**ADDENDUM 1  
TO THE CONTRACT PROVISIONS AND CONTRACT PLANS**

**NORTHSHORE UTILITY DISTRICT  
CONTRACT NO. 2020-01; LAKE FOREST PARK RESERVOIR AND BOOSTER  
STATION UPGRADES**

**G&O #19670**

**ISSUED THIS DATE: WEDNESDAY, NOVEMBER 4, 2020**

**SHEET 7 OF 28, RESERVOIR DETAILS**

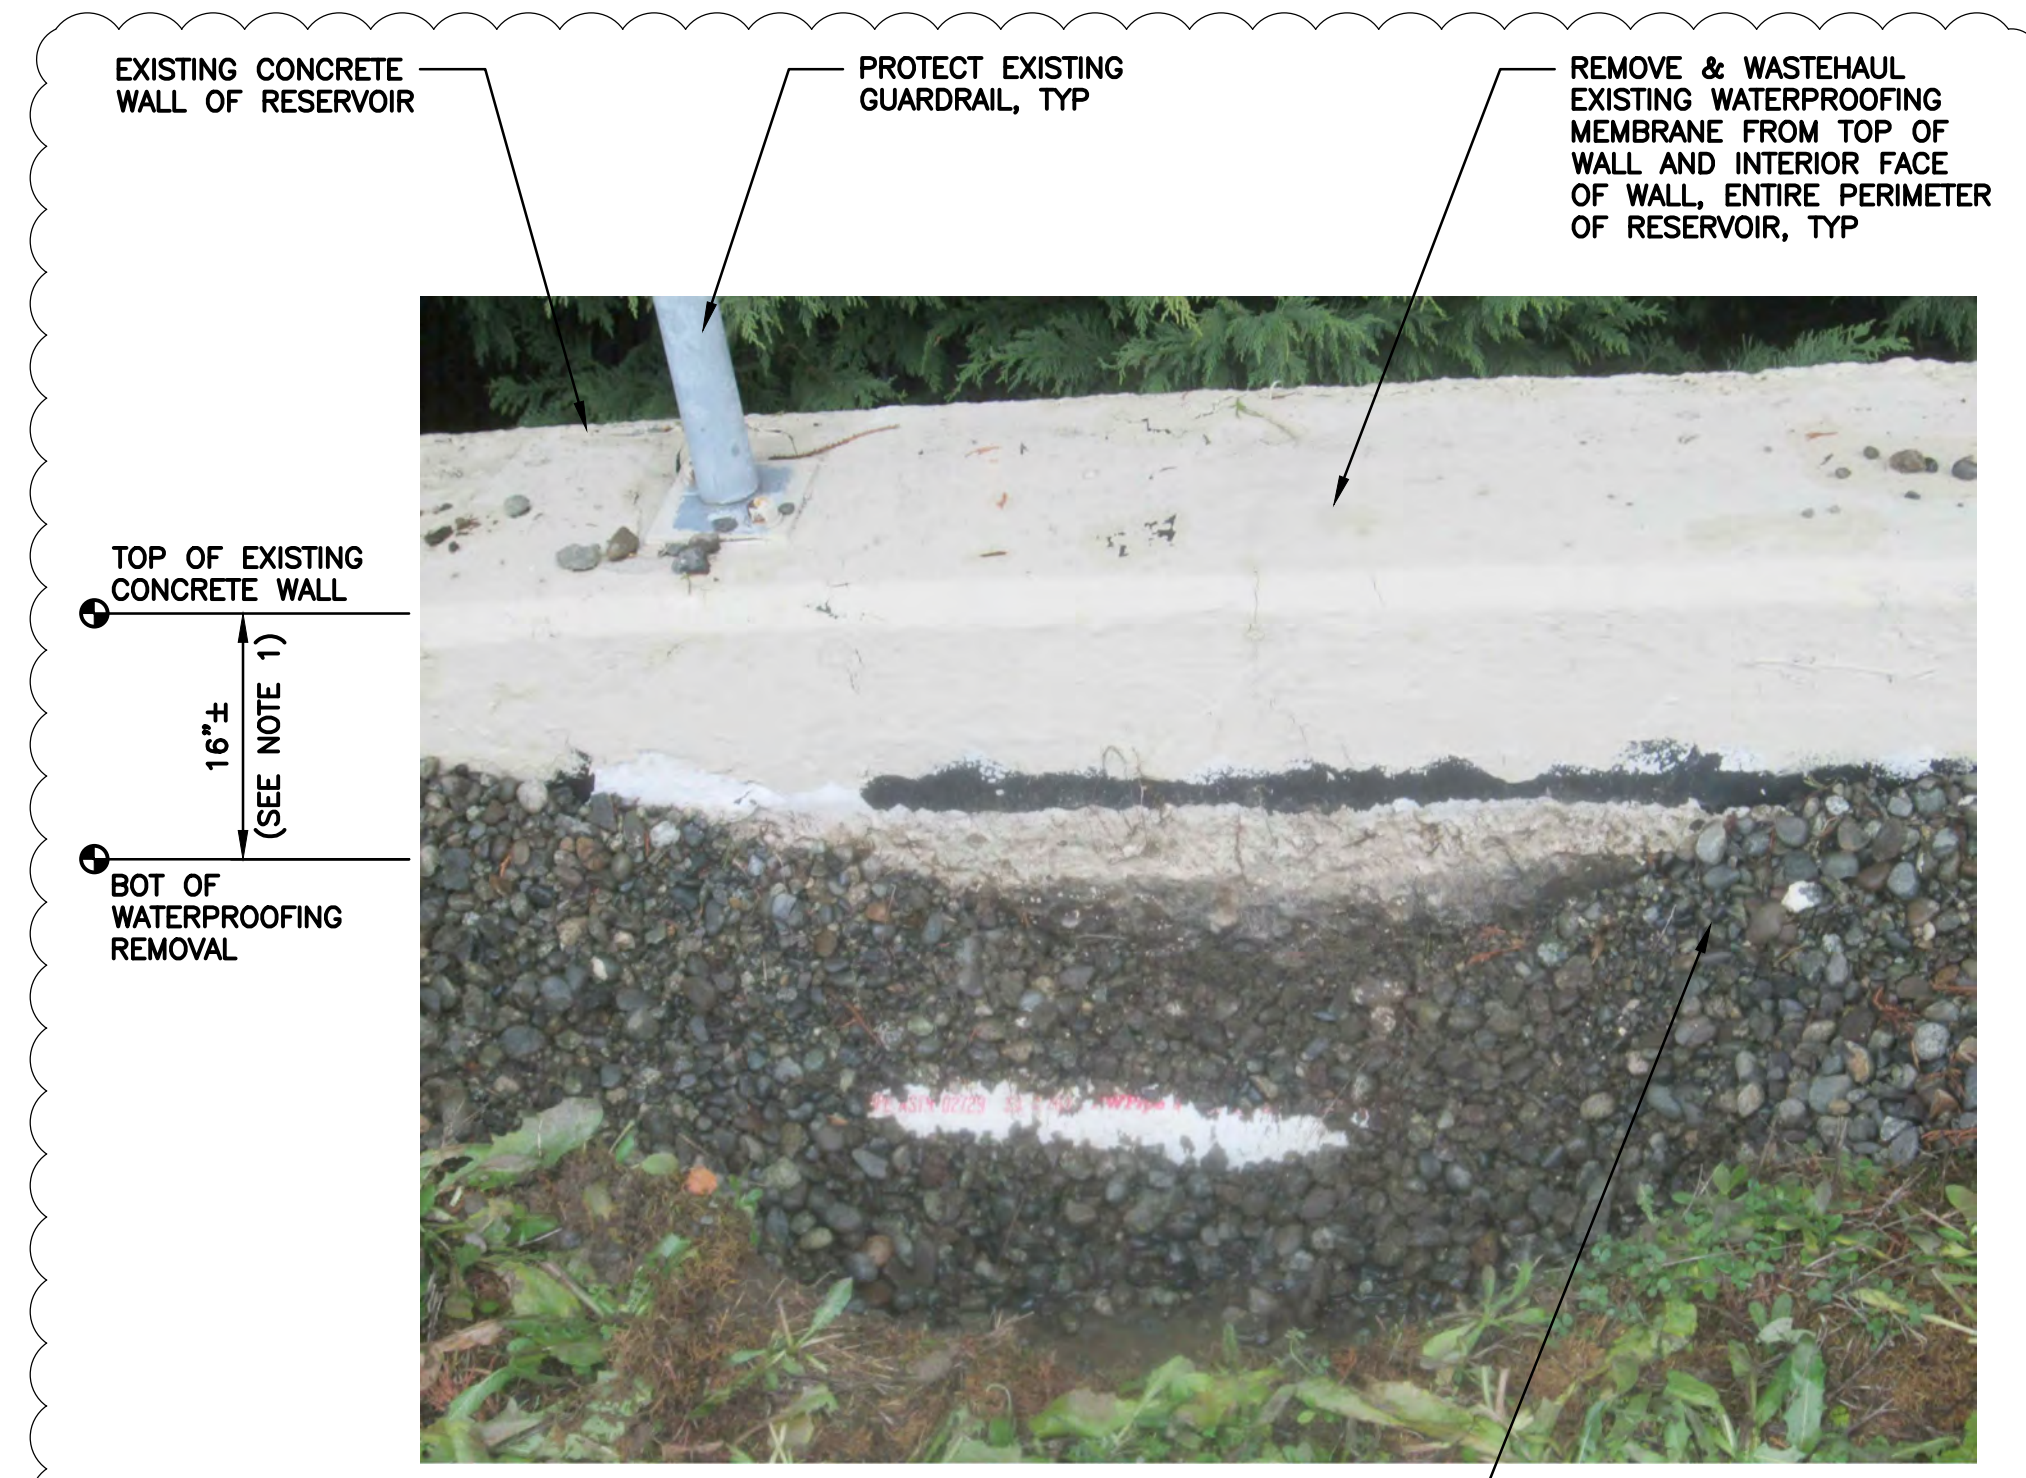
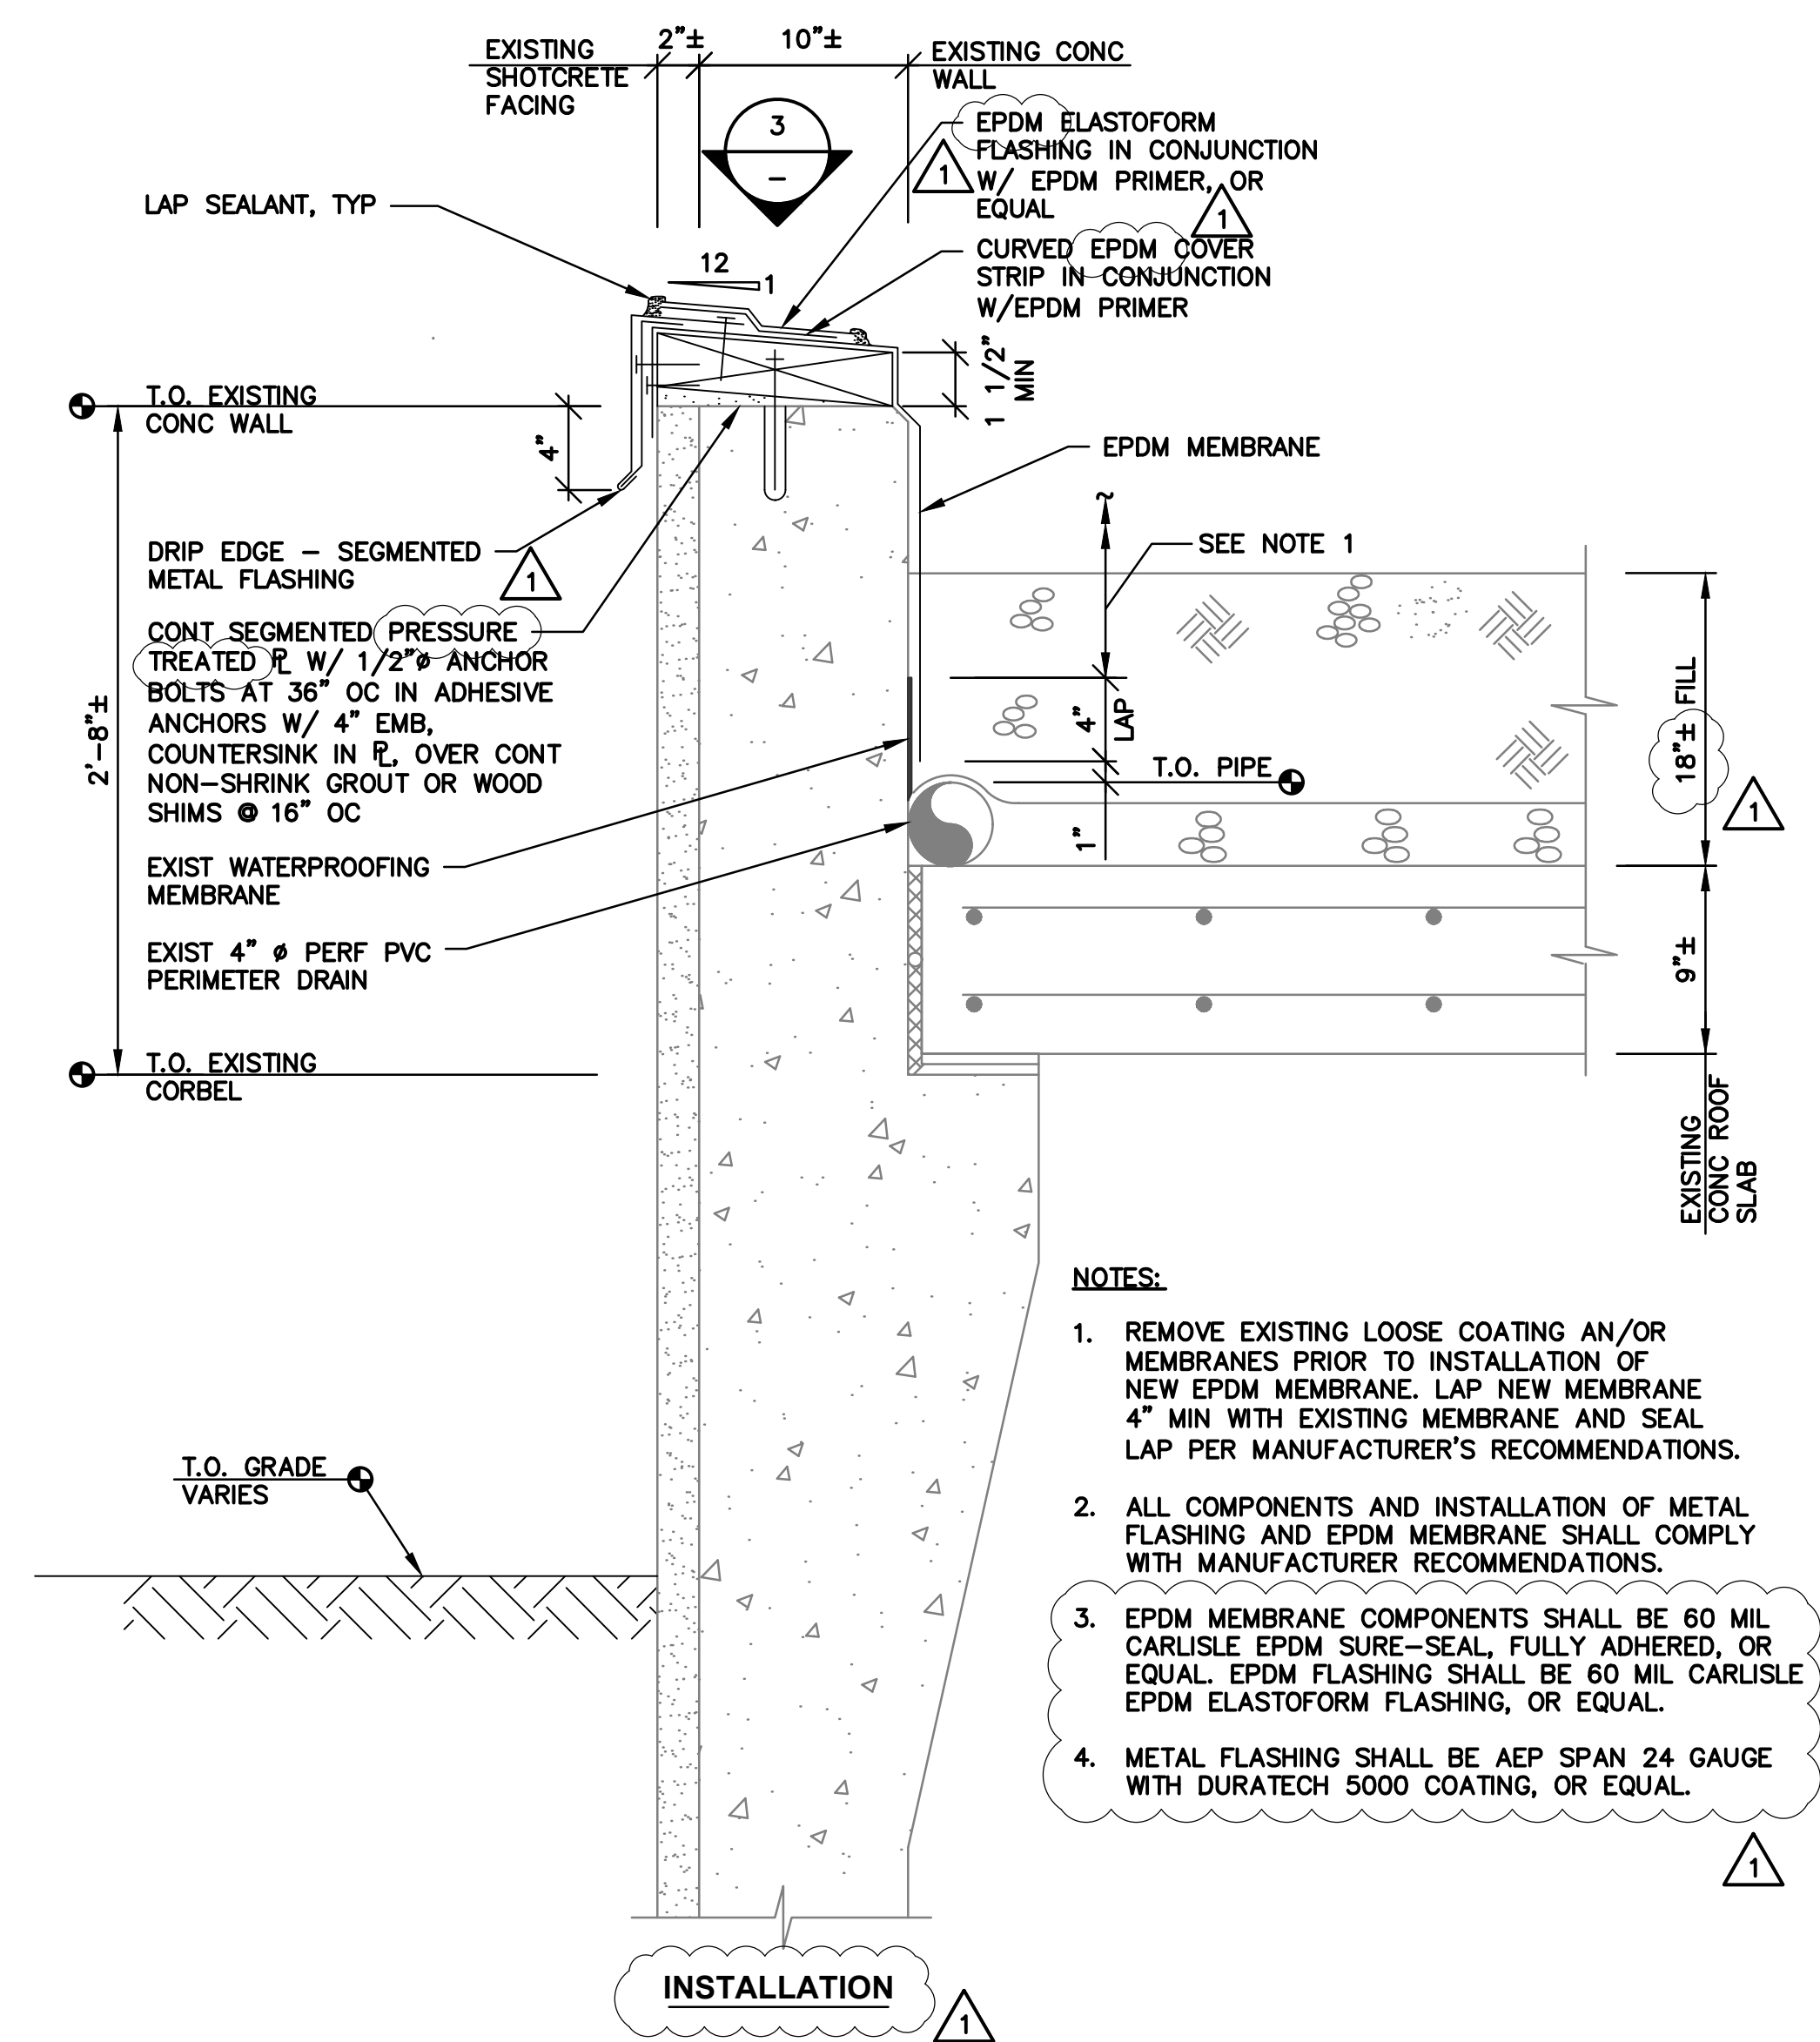
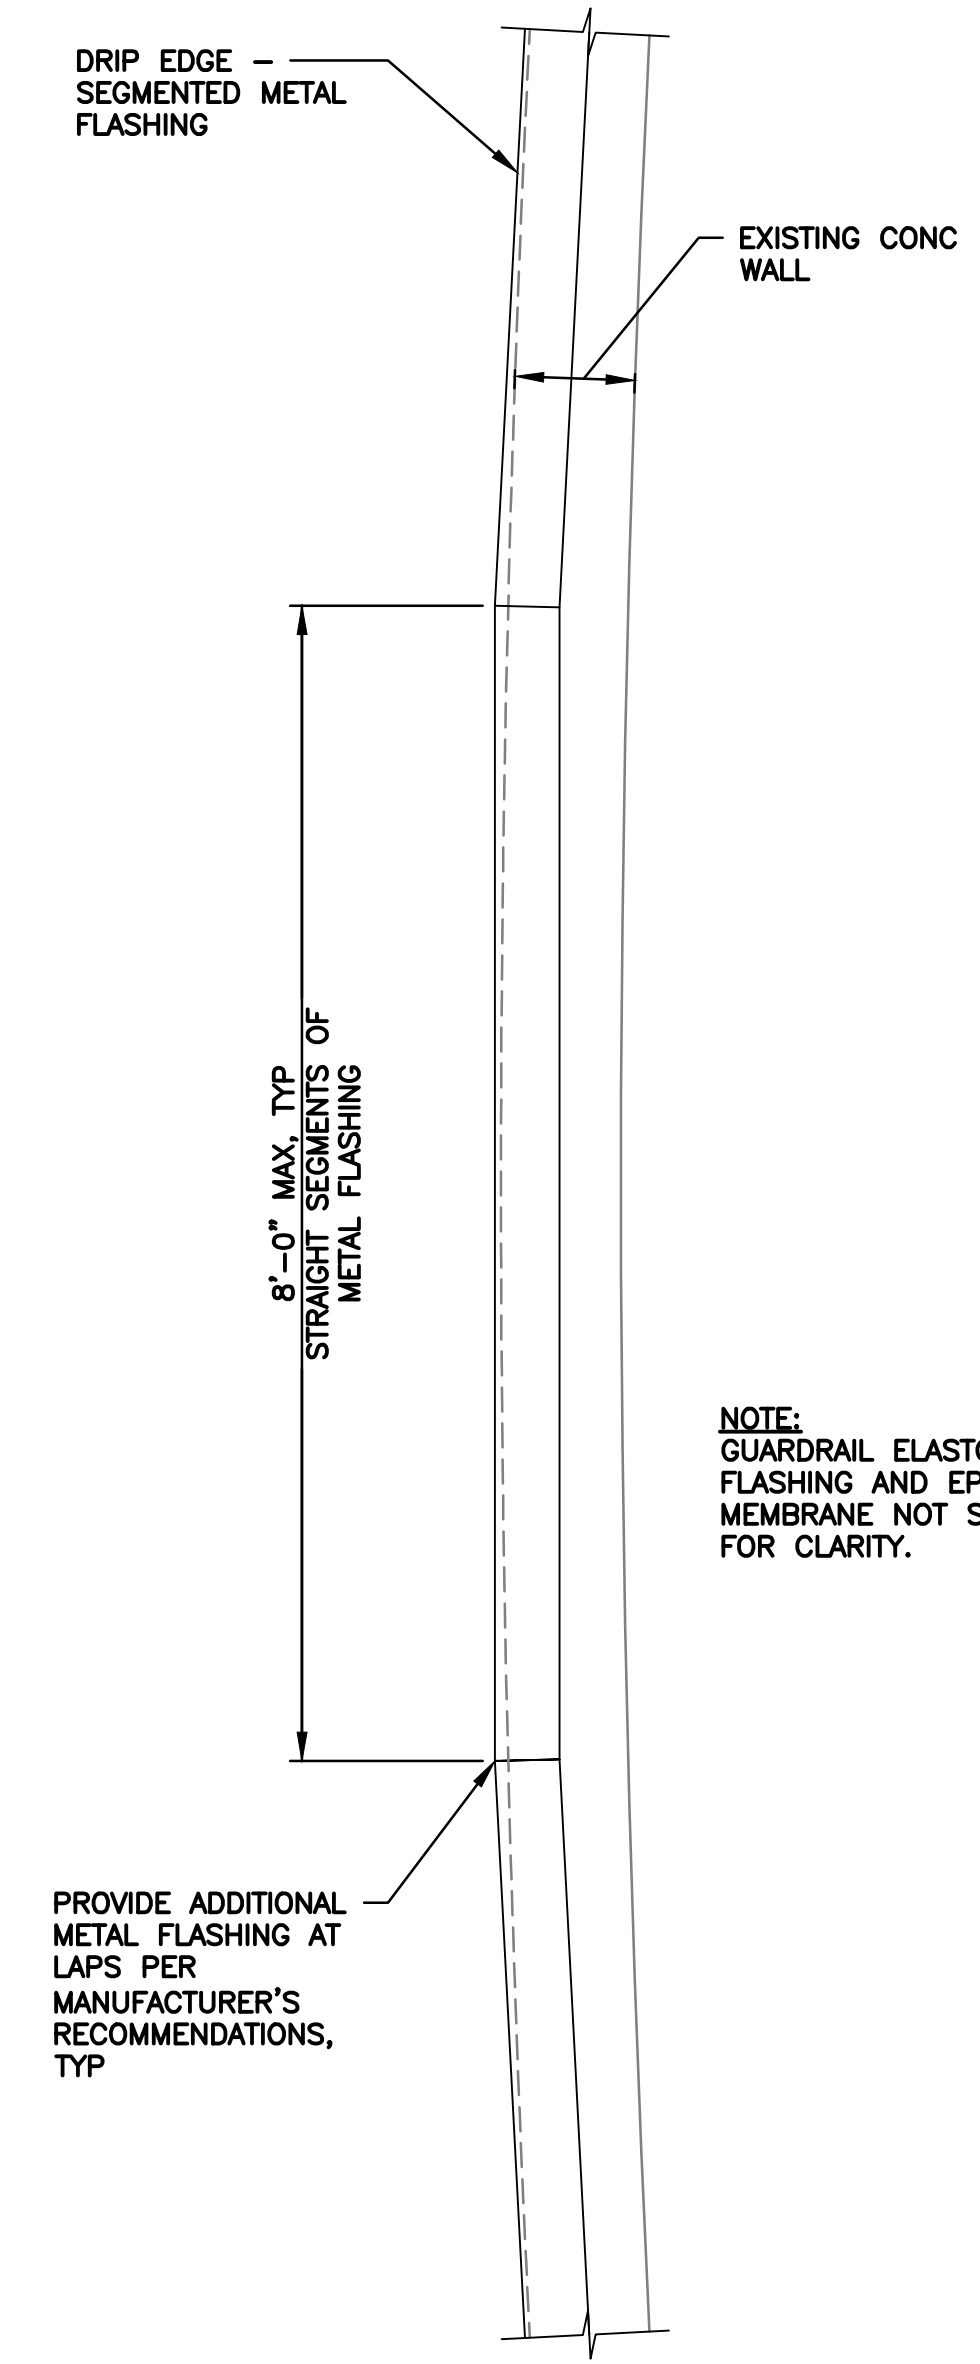
**DELETE** Sheet 7 of 28 in its entirety and **REPLACE** with the attached revised Sheet 7 of 28.
